PROJECT: Garrett College CEPAC

Item	Copies	Date	No.	Description	Status
Submittal	1	6/10/21	116103-001-02 Rev 2	THEATRICAL NETWORKED LIGHTING CONTROL SYSTEM	New
Attachment	1			Re: Submittal 116103-001-02 Rev 2 - Submittal 1's SPC Documents.pvsync

SPEC SECT:	LSF SUBMITTAL#:	REVISION#:	DESCRIPTION:	SUPPLIER:
116103	001-02	2	THEATRICAL NETWORKED LIGHTING CONTROL SYSTEM	PITTSBURGH STAGE INC

SCOPE OF WORK: Theatrical Networked Lighting Control

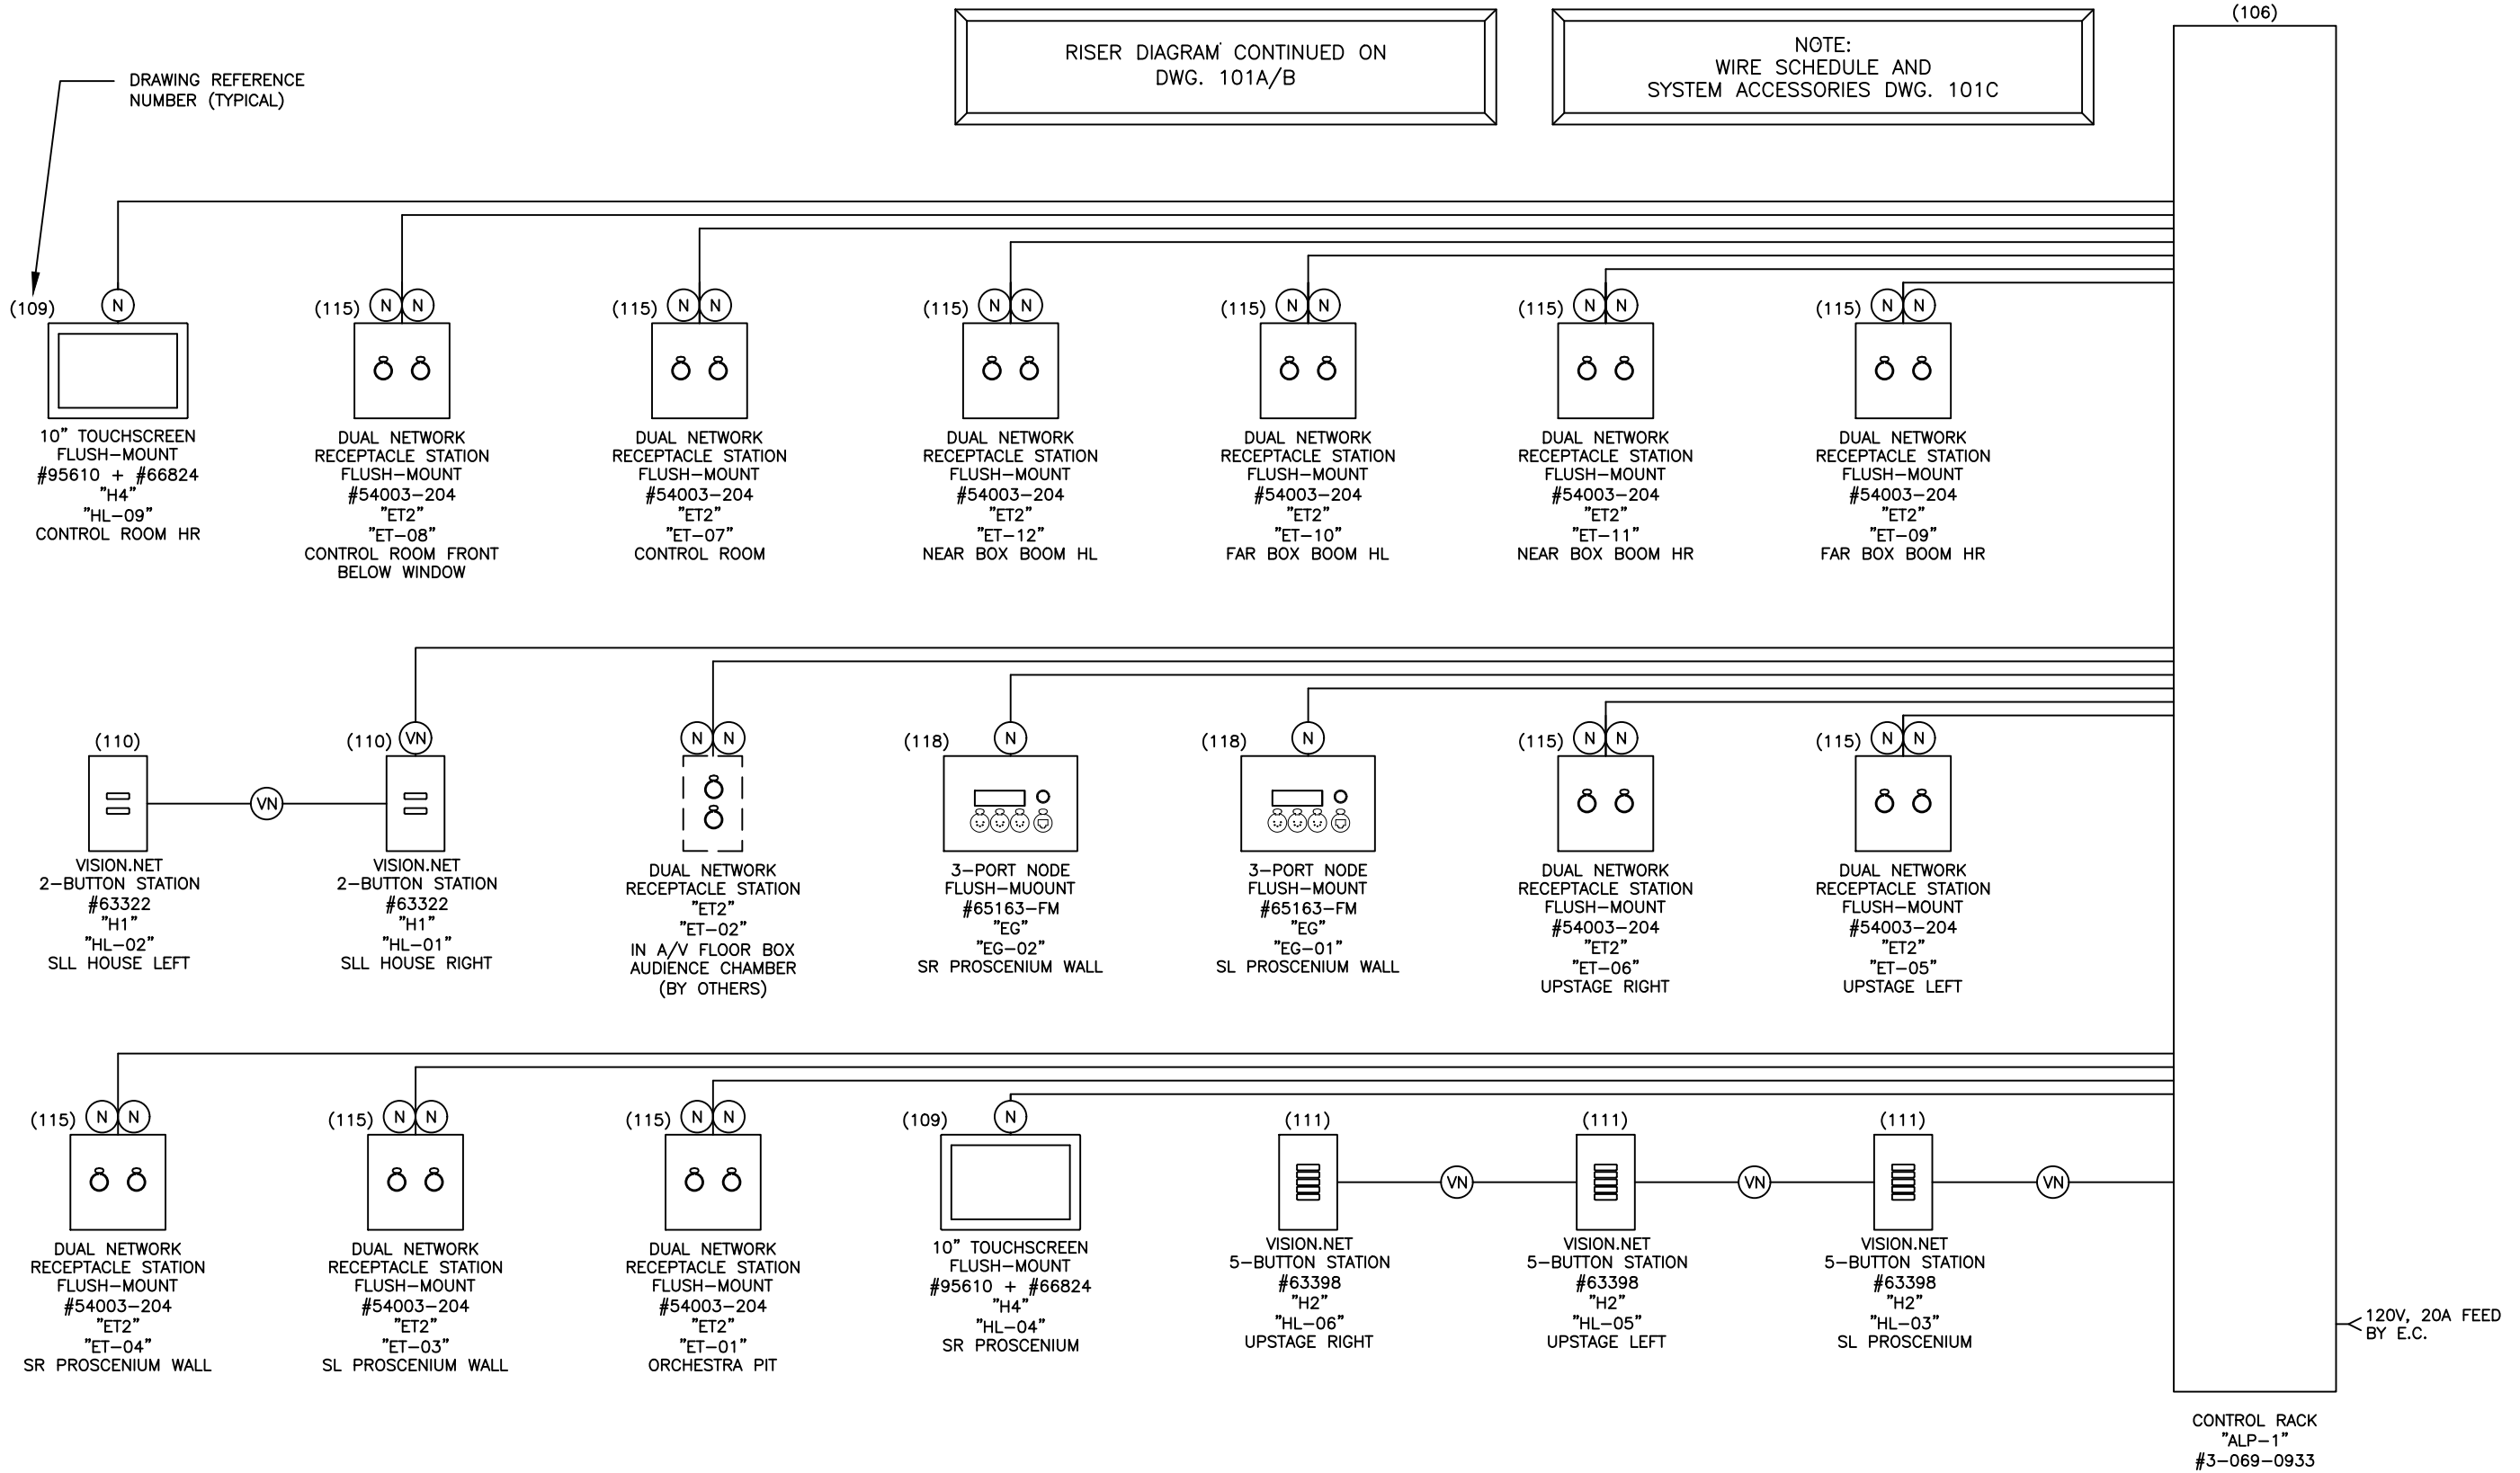
pr	A	03/24/21	REVISED "ET-02" DEVICE PER MARK UPS
APPVD	DWN	REV	DATE	REV DESCRIPTION

SYSTEM	
PROSCENIUM THEATRE	
DRAWING NO. 739460-101A	REV A

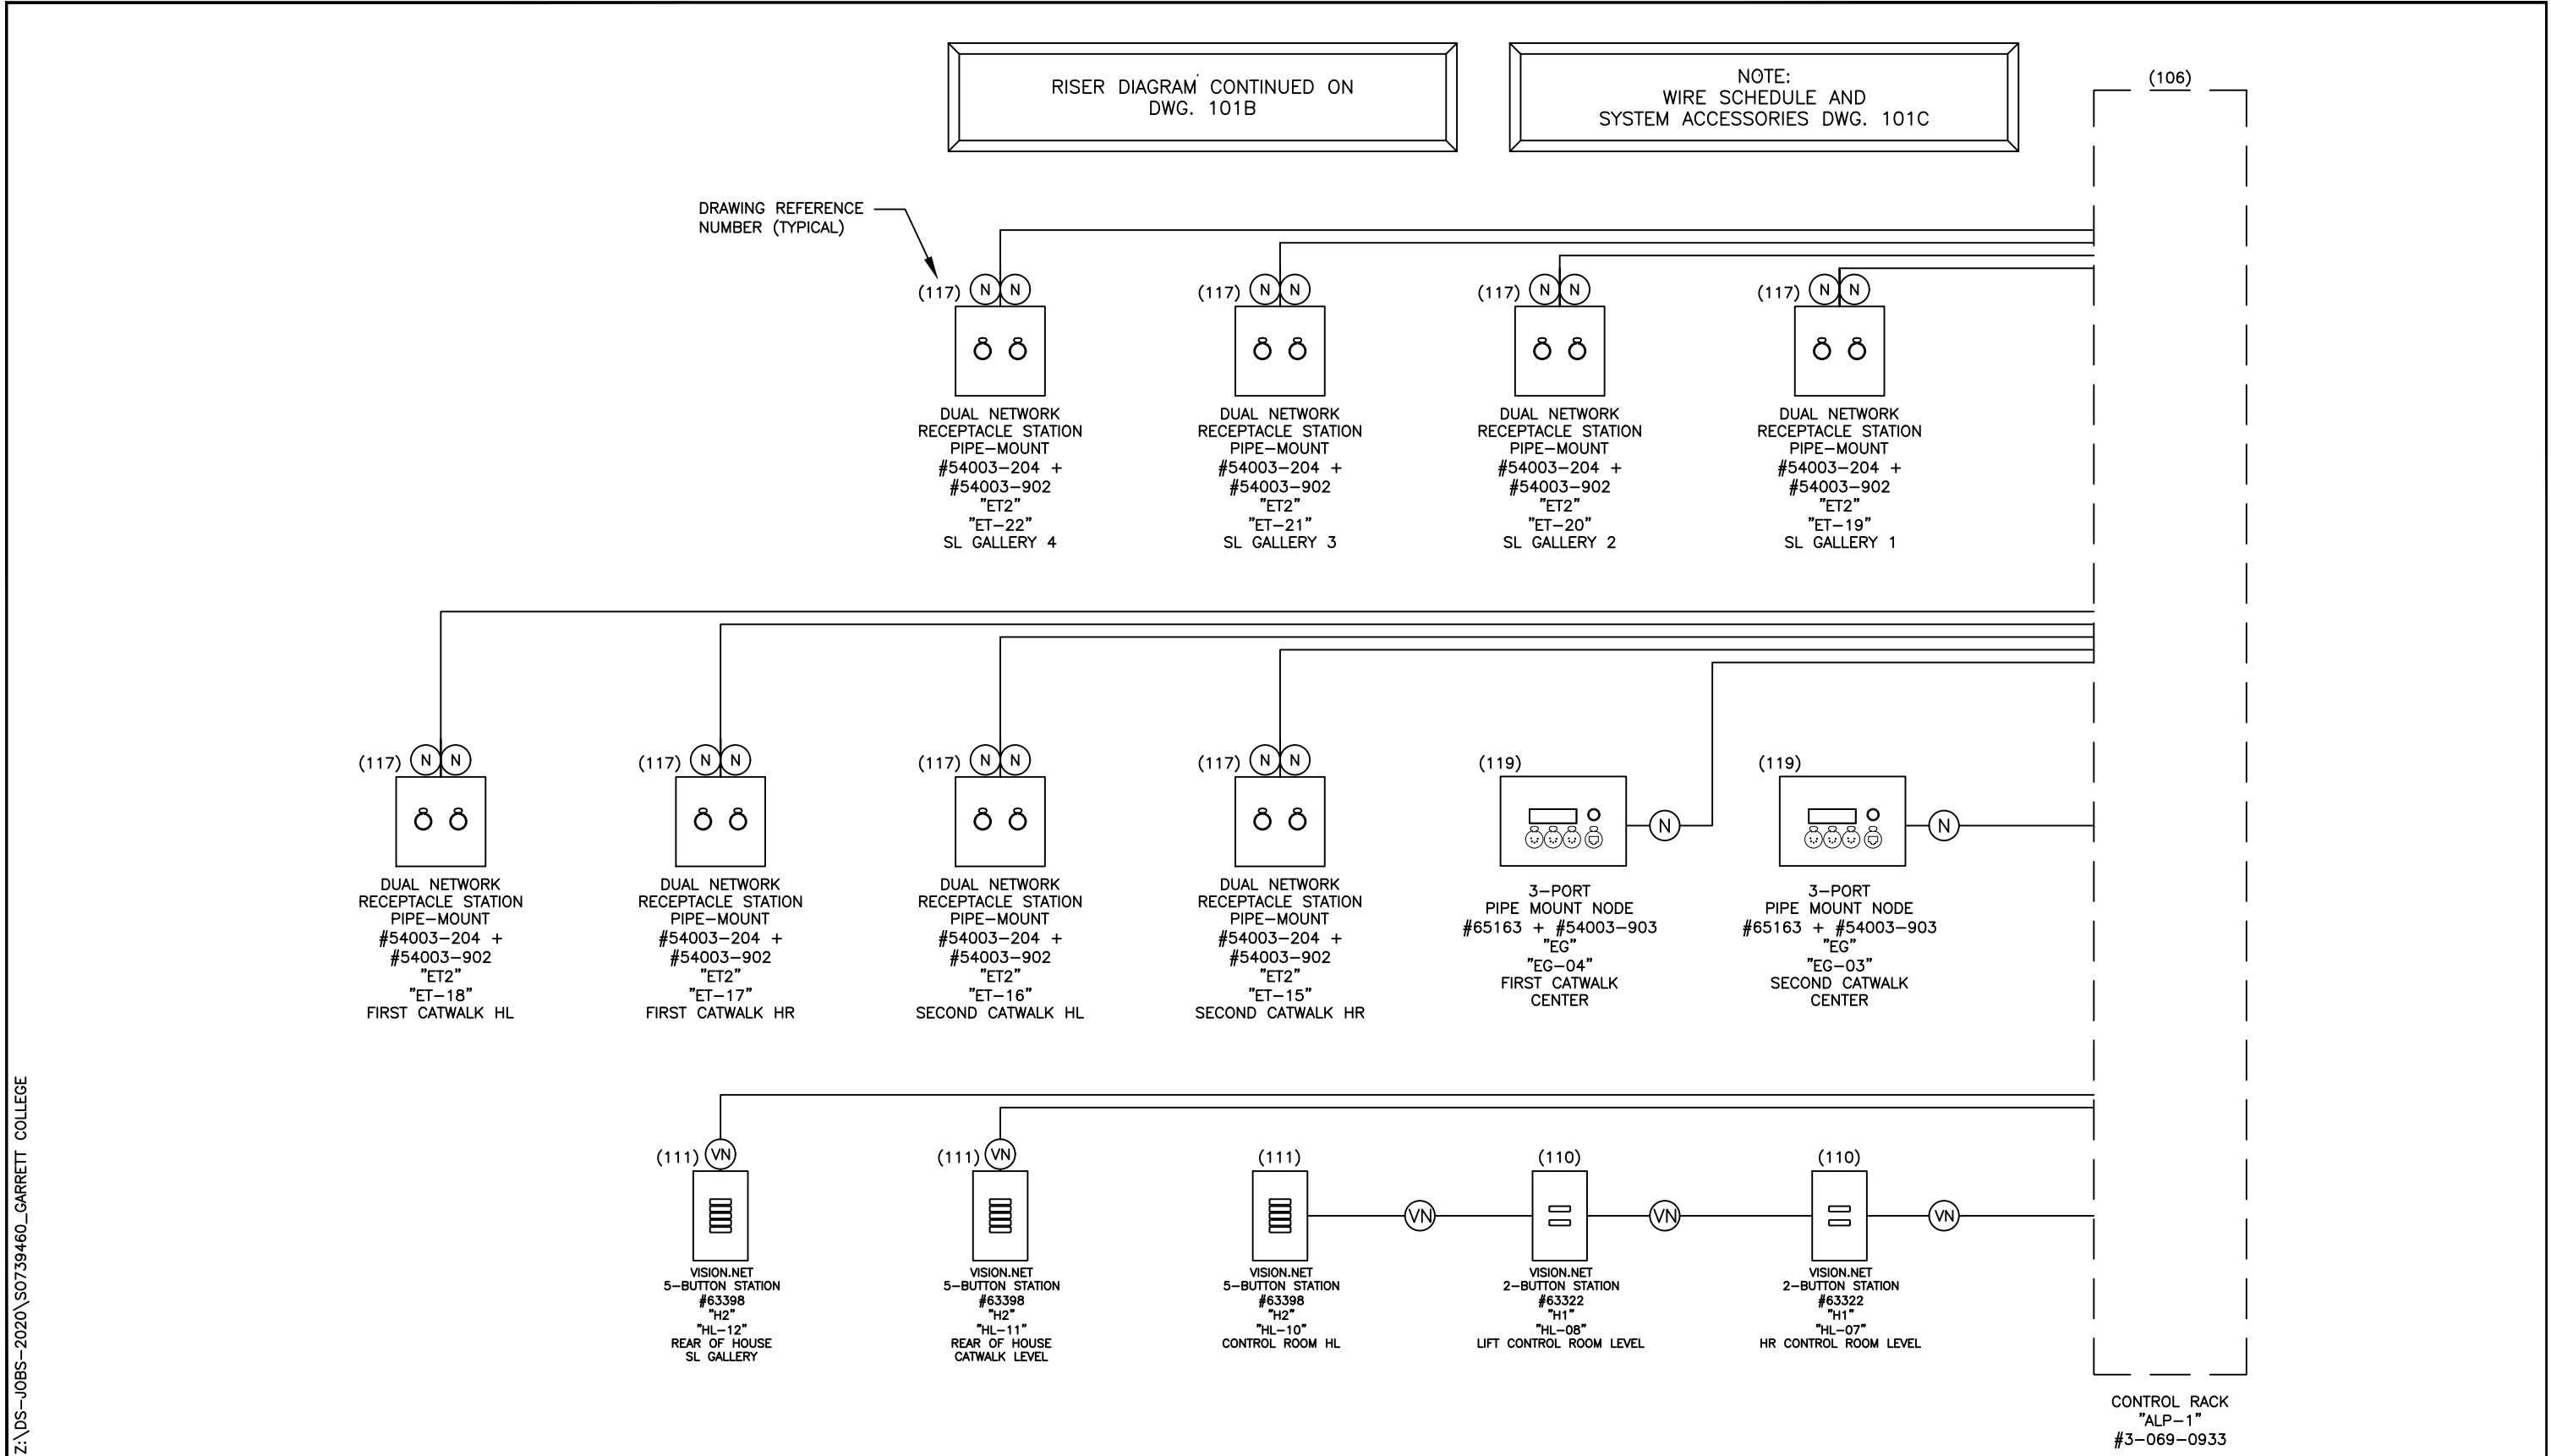
pr	A	03/24/21	REVISED "EG-03" & "EG-04" DEVICES PER MARK UPS
APPVD	DWN	REV	DATE	REV DESCRIPTION

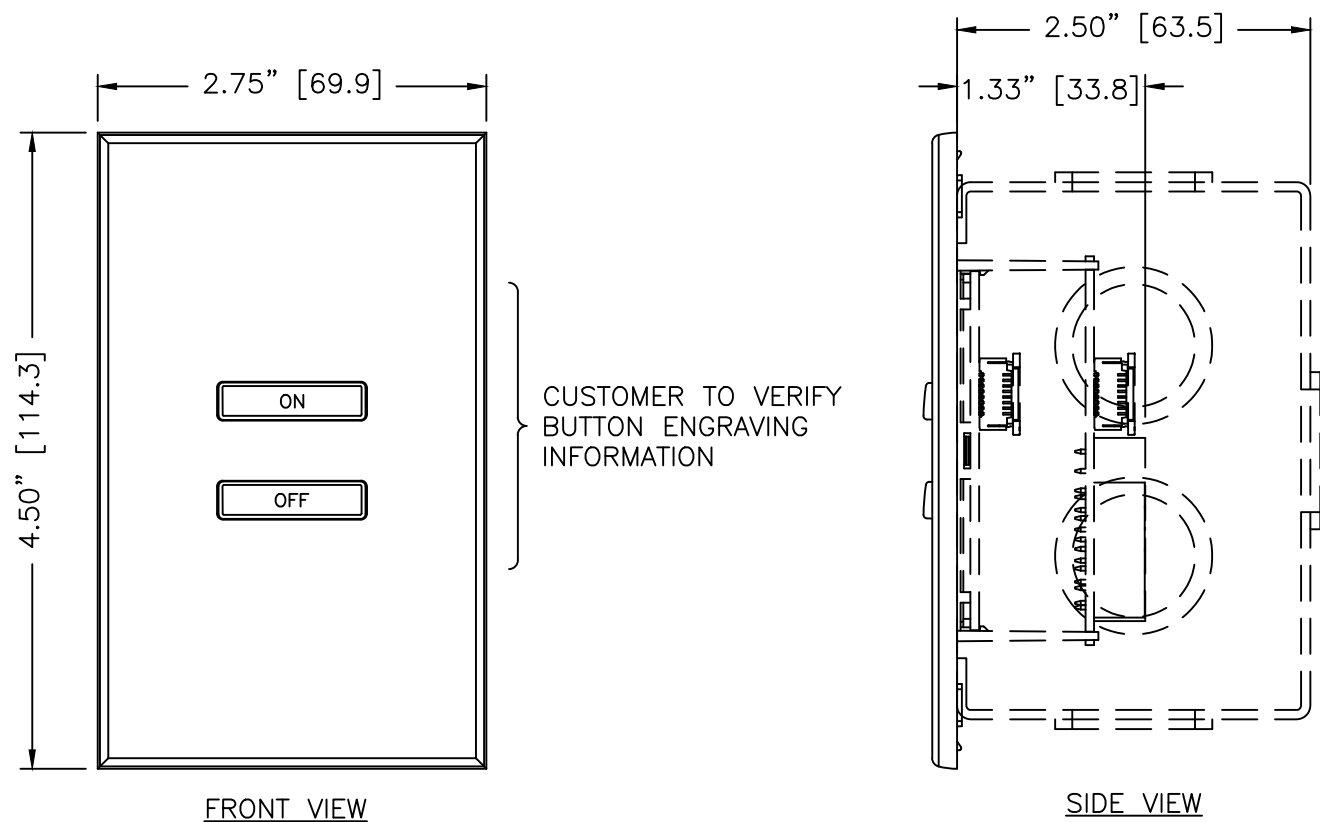
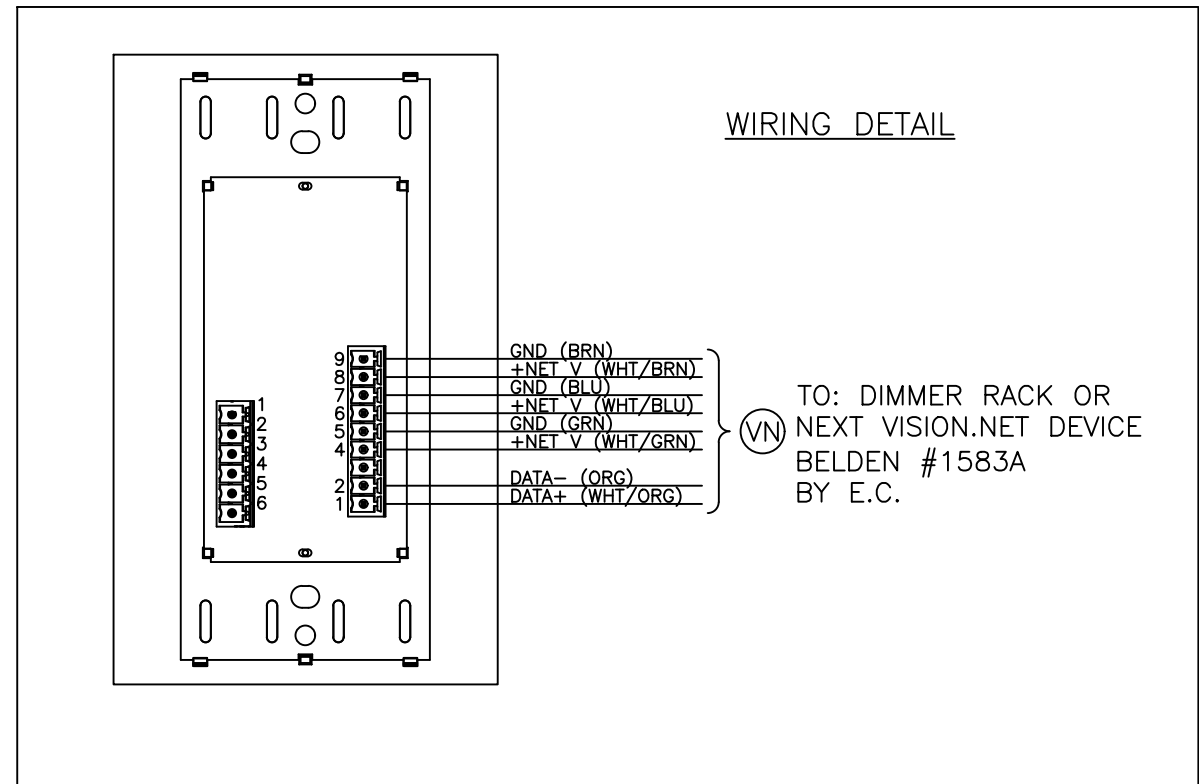
PR	A	05/19/21	REVISED COLOR SELECTION PER MARK UPS
APPVD	DWN	REV	DATE	REV DESCRIPTION
